Access Compliance Report Public Rights-of-Way (Curb Ramps)

Intersection ID: 10041624	Main Street: WHITEHALL EXECUTIVE CENTER DR	Access Street: N/A	Location: W
ADA ID: 1890A86E34C1	Ramp Type: Combination1	Initial Pass/Fail: Fail	Overall Compliance: No
		Severity Score: 1.25

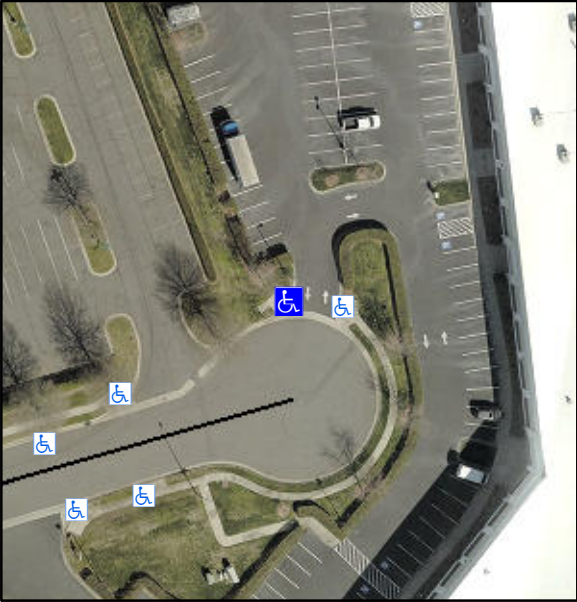
Codes/Mitigation Info/Possible Solution			Field Measurements/Component Compliance			
	Possible Solutions:		Compliance	Description	Data	
	Remove & Replace Entire Ramp.		N/A	Ramp Length LT (in)	38.0	
			Yes	Ramp Width LT (in)	48.0	
			Yes	Ramp Slope LT (%)	1.2	
			Yes	Ramp XSlope LT (%)	0.9	
			N/A	Ramp Length (in)	48.0	
			Yes	Ramp Width (in)	48.0	
	Surveyor Notes:		N/A	Flare Type LT	N/A	
	LT RP < 5%		N/A	Flare Slope LT (%)	N/A	
			N/A	Flare Traversable LT?	N/A	
	PROW/ADA:		N/A	Landing Length (in)	N/A	
	R304.5.3		N/A	Landing Width (in)	N/A	
			N/A	Landing Slope (%)	N/A	
			N/A	Landing X Slope (%)	N/A	
			N/A	Landing Curb? (Y/N)	N/A	
			N/A	Shared Landing?	N/A	
			N/A	Gutter Ponding?	N/A	
			N/A	Gutter Lip Ht (in)	N/A	
			N/A	Painted X Walk1?	No	
				X Walk 1 Direction	To E	
Street 1 Name	StopSign			X Walk 1 Width (in)	N/A	
Stop Condition-Street 1	ENTRANCE			X Walk 1 Slope (%)	1.8	
Street 2 Name	N/A			X Walk 1 X Slope (%)	3.7

Stop Condition-Street 2	N/A			Ramp inside XWalk1?	N/A	
Total Cost:		\$ 1800.00	N/A	Road Slope (%)	N/A	
				Road X Slope (%)	N/A	
				Clear Space?	N/A	
				Clear Space to XWalk (in)	N/A	
				Any Obstruction?	N/A	
				Obstruction Type		
						N/A
			N/A	Storm Grate/Utility Hazard?	N/A	
				Storm Grate/Utility Type		
						N/A
			Yes	Surface Condition? (G/P)	Good	
				Curb Slope (%)	2.4
